Appl'n No. 10/694,745
Amdt Dated July 6, 2004
Reply to Office Action Dated Apr. 6, 2004
Annotated Sheet Showing Changes (1 of 2)

FIG. 3A
PRIOR ART

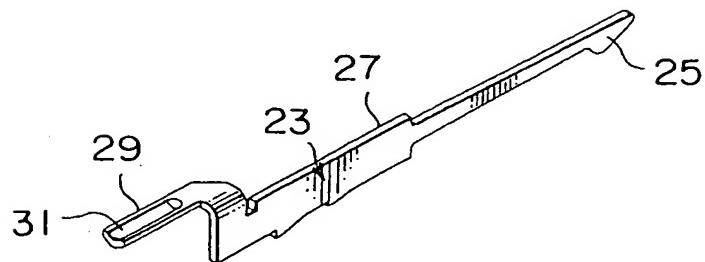
Similarly, with regard to the Office Action's remarks about the distinction between width and thickness, Applicant notes that the term "width" is used to describe the measurement of a portion of a contact in its thickness direction. Referring to **Fig. 3A**, Applicant describes "terminal portion 29 [of contact 23] having a width in a thickness direction of contact 23 . . ." Appl'n, Para. [0037]. Moreover, referring to **Fig. 4D**, "numeral 6 denotes the width (height) of the contact." Appl'n, Para. [0046].
